## **2.5 Geology, Seismology, and Geotechnical Engineering**

In Section 2.5, "Geology, Seismology, and Geotechnical Engineering," of the SSAR, SERI provided a detailed description of the geological, seismological, and geotechnical engineering properties of the ESP site. In this SER, Section 2.5.1, "Basic Data," describes basic geological and seismological data, especially the data published since 1986 for the area within a 200-mile radius of the ESP site, and presents updated seismic sources. Section 2.5.2, "Vibratory Ground Motion," evaluates the vibratory ground motion for the ESP site and analyzes the safe-shutdown earthquake (SSE) ground motion. Section 2.5.3, "Surface Faulting," describes the potential for surface faulting at or near the surface of the ESP site. Section 2.5.4, "Stability of Subsurface Materials and Foundations," presents the results of site geotechnical investigations and discusses the stability of subsurface materials and foundations. Section 2.5.5, "Stability of Slopes," defers the analyses for slope stability at the site and dam performance, respectively, to the COL stage. Finally, Section 2.5.6, "Embankments and Dams," briefly states that no embankments e

**Figure 2.5.4-11 (Updated final version of SSAR Figure 2.5.4-93)  
 Shear Modulus Reduction Curves for Upland Complex Alluvium at  
 4X Confining Stress**

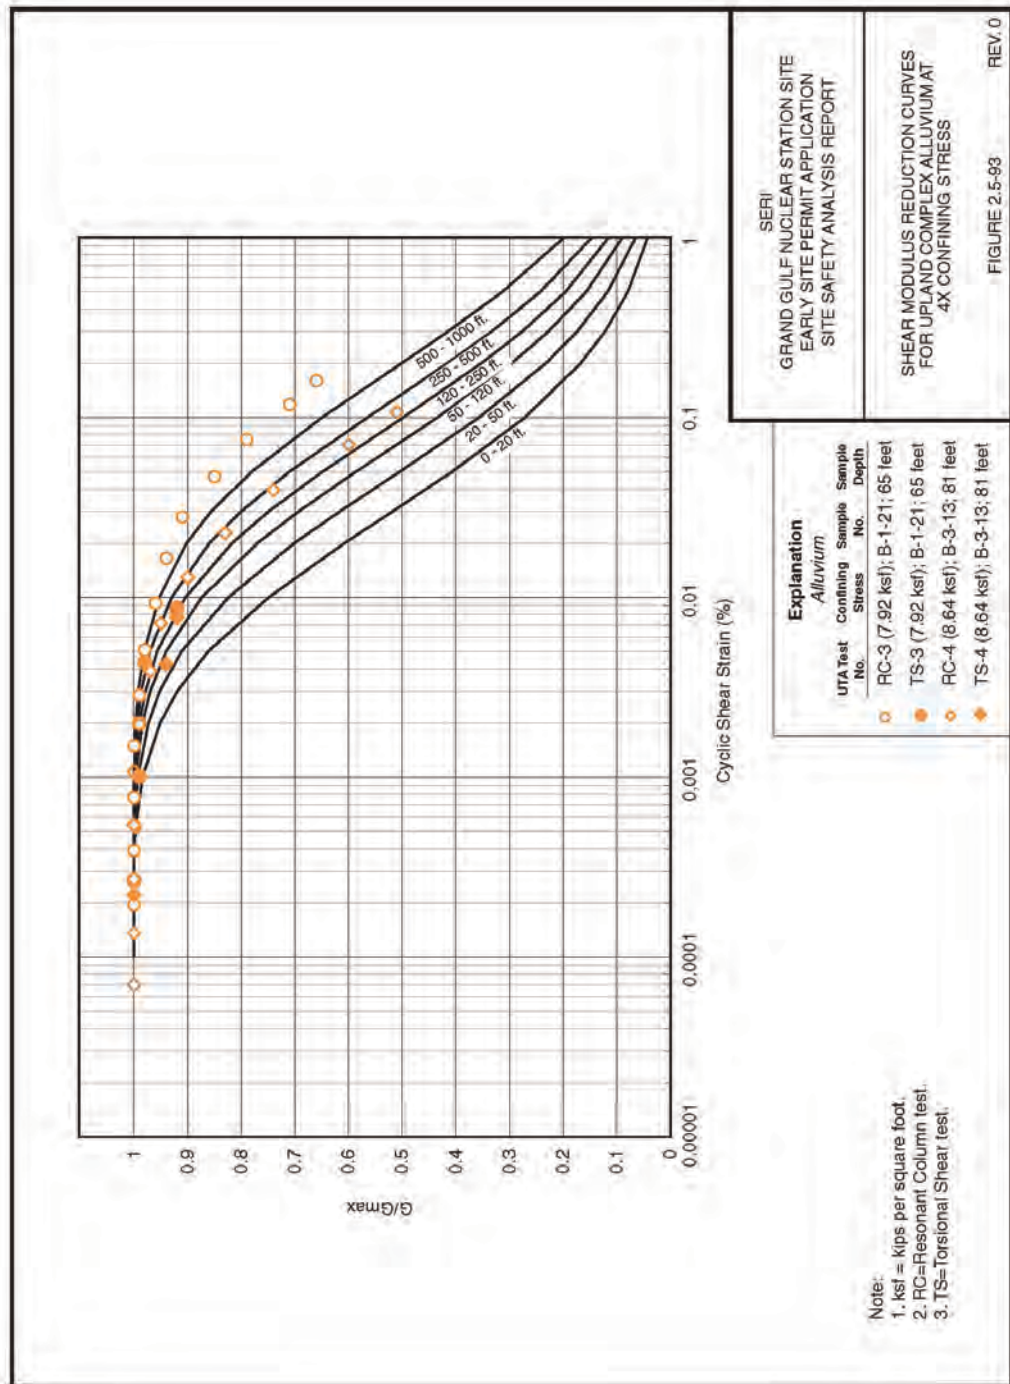
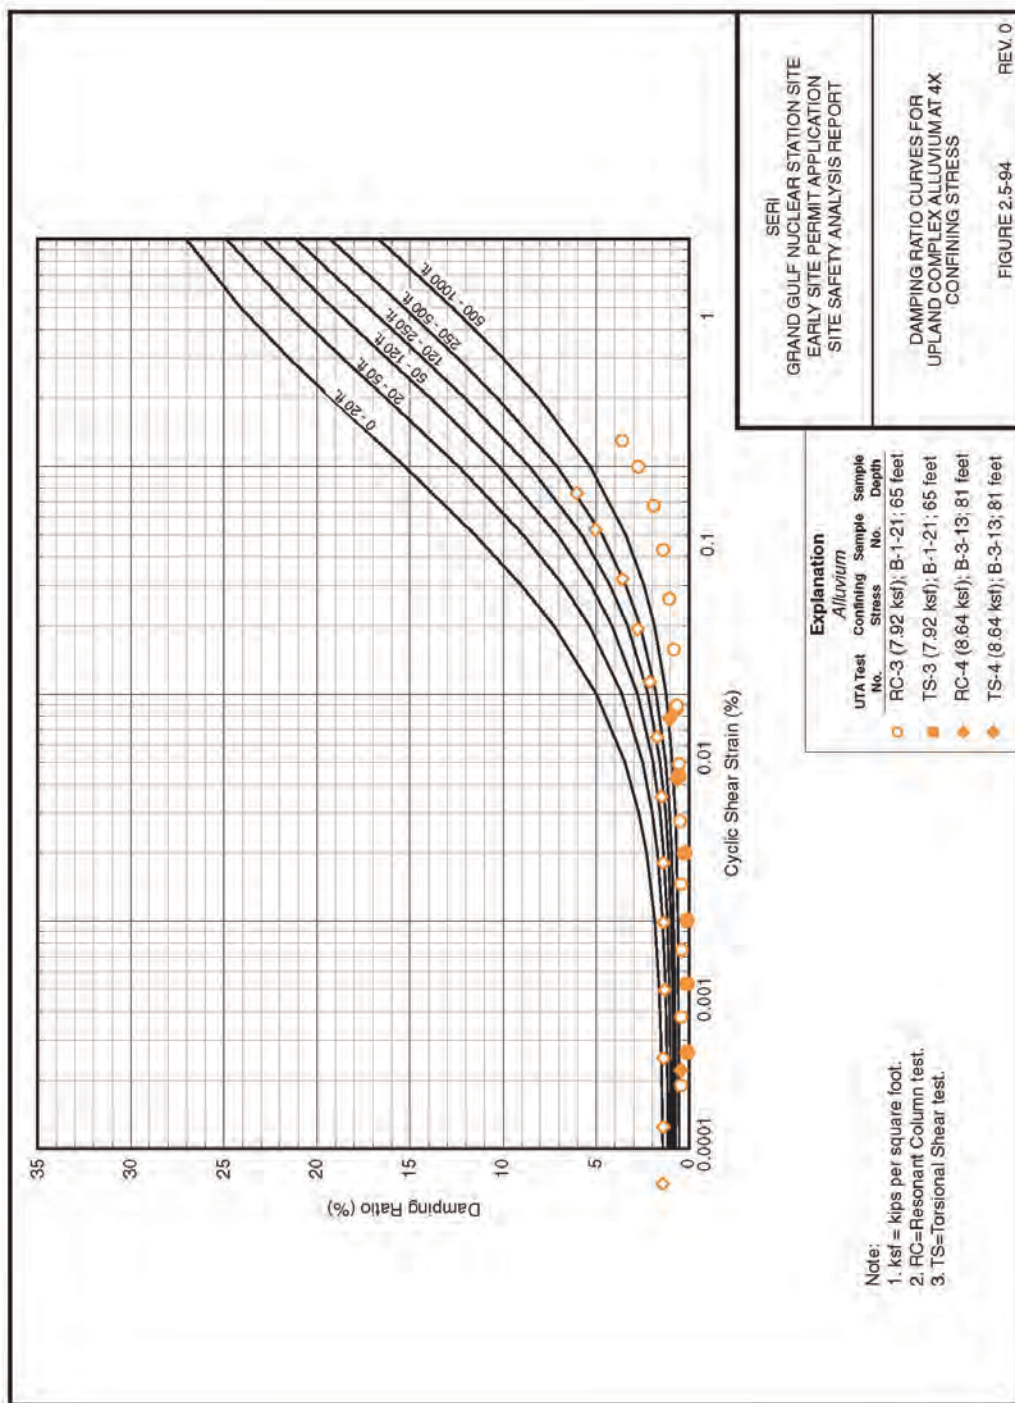
In RAI 2.5.4-7, the staff asked the applicant to provide its rationale for not incorporating these effects in the site response calculations and to evaluate the potential impact of these modifications on the computed surface UHRS. In its response, the applicant referred to its response to RAI 2.5.4-6 and stated that the analysis and selection of the appropriate EPRI-TR curves for shear modulus reduction and hysteretic damping fully account for the effects of possible disturbance to the test specimens resulting from stress release during sampling, as well as possible movements during testing. The applicant considered the effects of sample relaxation by examining the results from testing soils at both the estimated in situ confining stress and 4 times the estimated in situ confining stress. The applicant plotted these two data sets together on the EPRI-TR base curves as shown in Figures 2.5.4-5 through 2.5.4-12, which replicate SSAR Figures 2.5.4-87 to 2.5.4-94. The two data sets were weighted to select the most representative EPRI-TR curve.

In its response, the applicant further stated that the shear modulus reduction and damping curves adopted for use in the site response analysis represent the best fit to the dynamic soil test results that account for the effects of soil disturbance and overconsolidation. The applicant also considered the uncertainty and variability in these values in the site response modeling by developing randomizing curves about the selected base case EPRI-TR curves using an assumed lognormal distribution. The applicant further discussed the randomization process in its response to RAI 2.5.4-8 (for shear wave velocity input). The applicant considered that the EPRI-TR curves selected for the base case for site response analysis are appropriate for the site soil conditions and account for both sample disturbance and overconsolidation. Therefore, incorporation of these issues would not impact the computed surface UHRS.

**Figure 2.5.4-13 (Figure 2.5.4-4-1 of the RAI response)  
Deep Profiles for Sensitivity Analyses**

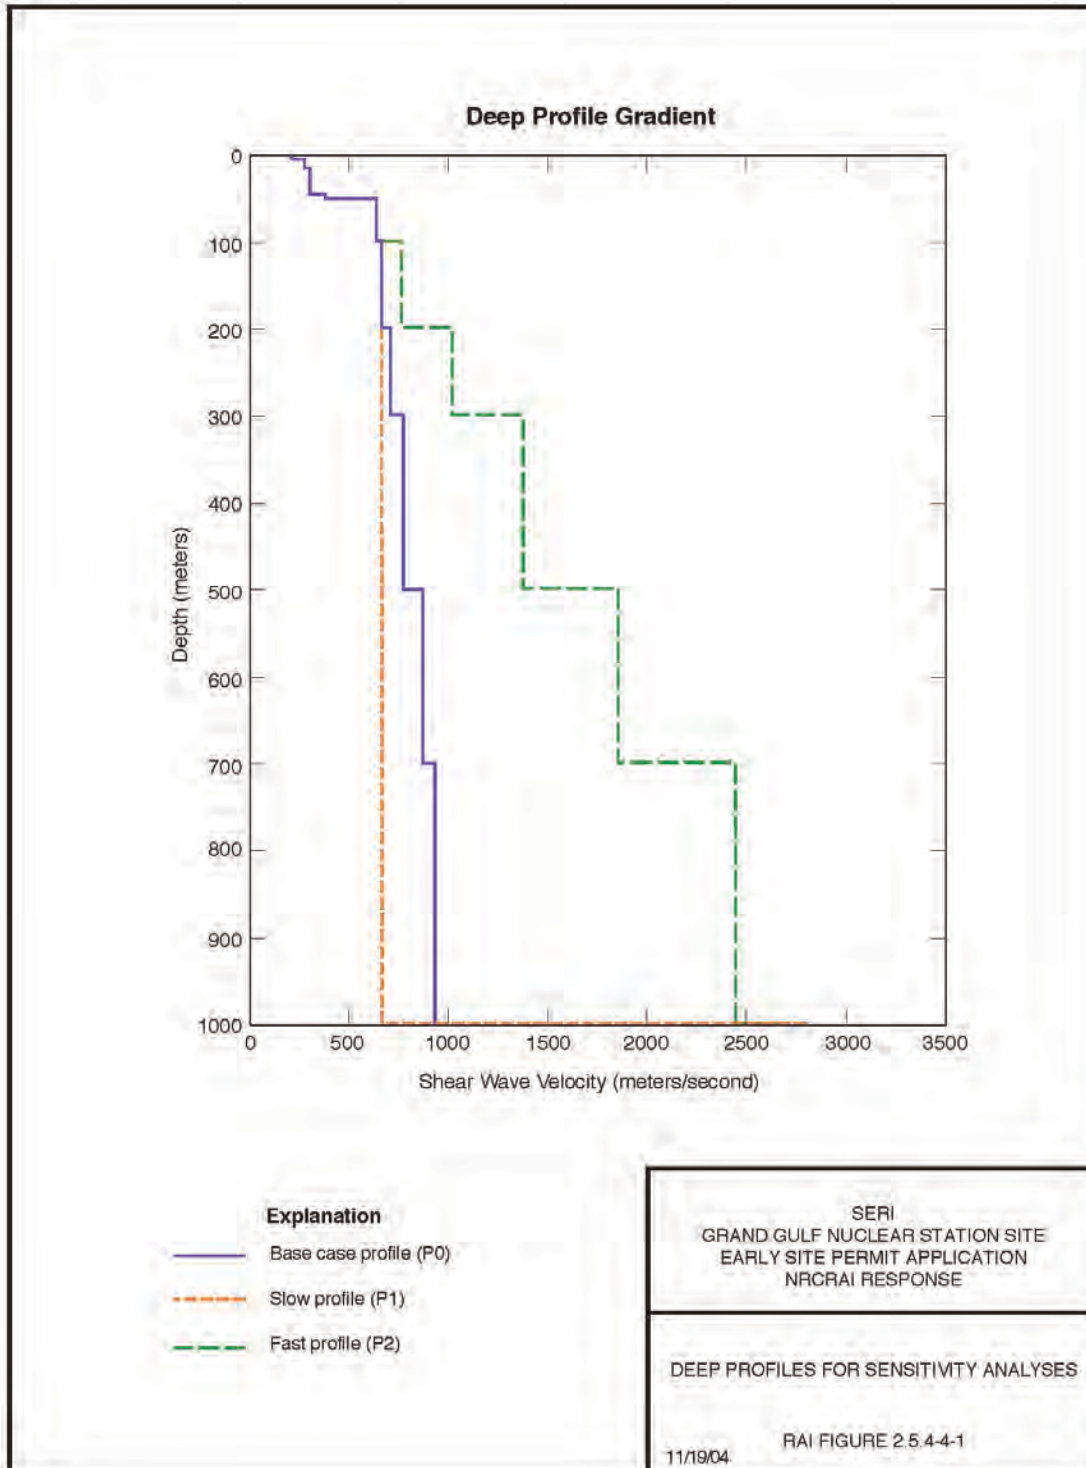
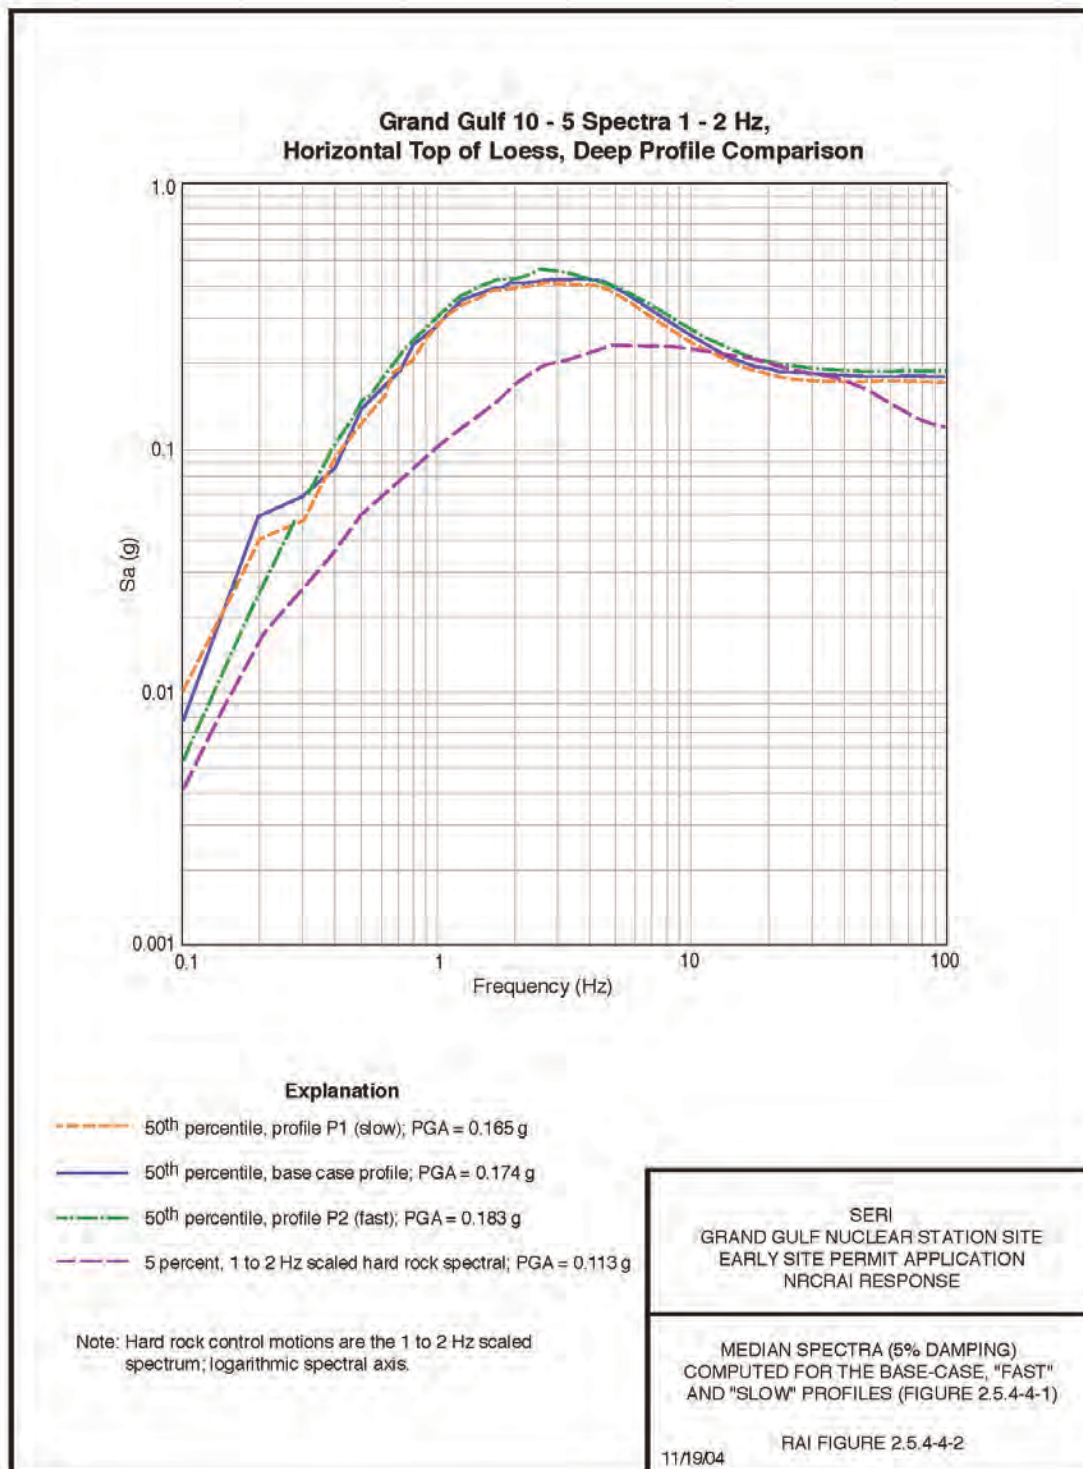
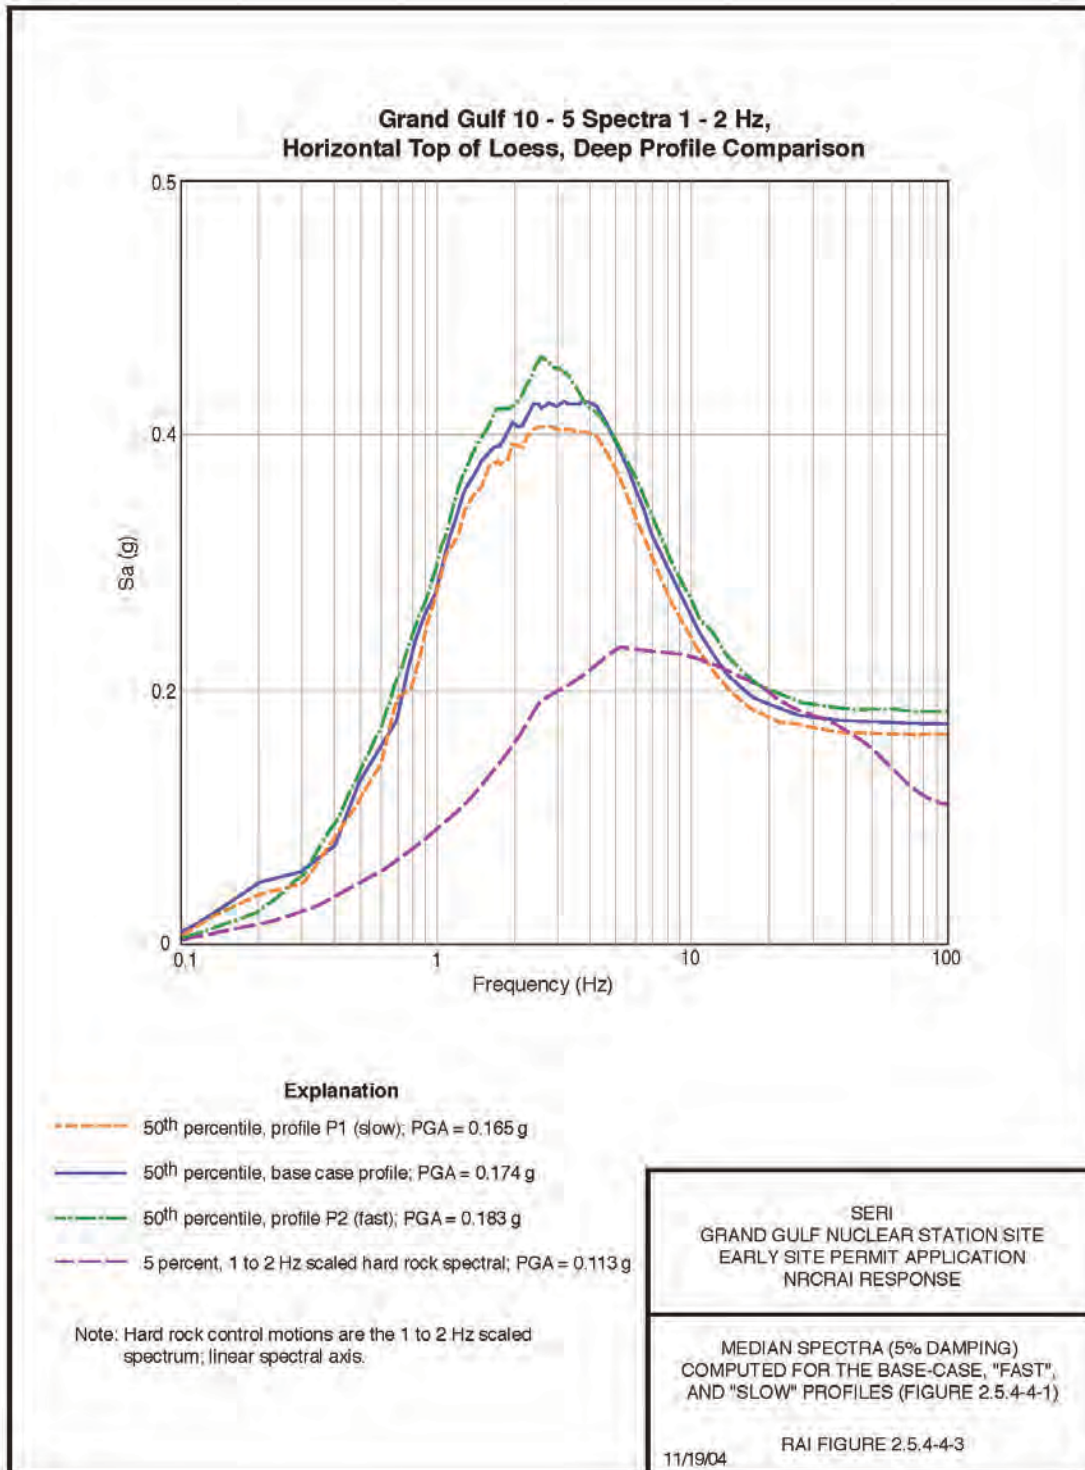
In seismic response analyses, shear and compression wave velocities, material densities, and strain-dependent modulus reduction and hysteretic damping data are necessary for the entire soil column extending to the depth considered in the site response evaluation. As indicated in Figure 2.5.2-4, the applicant assumed that the hard rock, with a shear wave velocity of 9186 fps, is located at a depth of 3281 feet and adopted a generic profile proposed for the Mississippi embayment region. This shear wave profile is relatively smooth, with a shear wave velocity varying from approximately 820 fps at the ground surface to a value of 9186 fps at a depth of 3281 feet. The applicant also replaced the upper 197 feet of the profile with a site-specific velocity profile generated by the geophysical program described previously. Therefore, of the entire 3281 feet of the profile, only the upper 197 feet are reasonably constrained. No site-specific information is available below this depth. However, it is a common practice for the sites where critical facilities are located to have one or more base case shear wave velocity models from site-specific data (e.g., well logs and deep borings) and then to generate soil UHRS using the probabilistic method of NUREG/CR-6728. In RAI 2.5.4-4, the

The staff also asked the applicant to compare the values of shear wave velocity to the BE, UB, and LB values used in the site response calculations. In its response, the applicant stated that Figure 2.5.2-4, which replicates SSAR Figure 2.5-60, presents the BE velocity profile adopted for the site soil response analysis. This velocity profile is based on a visual average of the composite P-S velocity profiles from the three ESP boreholes. It is an averaged, smoothed profile that does not use extreme values. The BE profile consists of five separate interval velocities that incorporate velocity data that were binned differently than the various general and estimated velocity ranges described for different stratigraphic units. The BE interval velocities of the site soil response velocity profile are not set at stratigraphic unit boundaries but rather are assigned at visually determined velocity breaks in the composite P-S profile. For this reason, the BE site soil response average velocities are not centered on the mean values listed for soil layers in ER-02 Table 8.2.

Figure 2.5.4-13 shows the base case shear wave velocity profile to the analysis depth of 1 kilometer along with two extreme cases for extrapolation to the hard rock shear wave velocity of 2.8 km/s. The slow profile assumes a uniform extension of the velocity just beneath the site to 1 kilometer, with a jump to the hard rock value of 2.8 km/s. As another extreme alternative, the fast profile assumes a linear (modeled as a stair step) gradient with depth, reaching 2.8 km/s at a depth of 1 kilometer. Based on general experience with measured shear wave velocity profiles in large sedimentary basins, the applicant expected the slow and fast profiles to reflect extreme (i.e., low likelihood) conditions, particularly with regard to the local and regional overall geology.

To compare the median motions computed for the three profiles, the applicant stated that it used the 1- to 2-Hz-scaled  $10^{-5}$  APE spectrum as the control motions to excite the column at low as well as high frequency since it is quite similar to the UHRS and sufficiently broad band (i.e., large magnitude) compared to the UHRS. Figures 2.5.4-14 and 2.5.4-15 show the resulting soil median motions in both the logarithmic and linear spectral axes, respectively. As expected, little difference exists between the motions computed for the three profiles from 0.3 to 100 Hz. At peak acceleration, the fast and slow profiles show about a 5-percent increase and decrease, respectively, in motions, as compared to the base case profile. The motions reflecting the fast profile generally exceed those of the base case by about 5 percent. The largest exceedance is near a resonance at about 3 Hz, at which the fast profile motions exceed the base case motions by about 10 percent. Based on regional geology as well as experience with similar geology in deep basins, this fast profile is extremely unlikely and would receive very low weight in a hazard analysis. The applicant stated that these site response analyses illustrate the general insensitivity of the motions to the nature of velocity gradients likely to exist in the deep materials beneath the site.
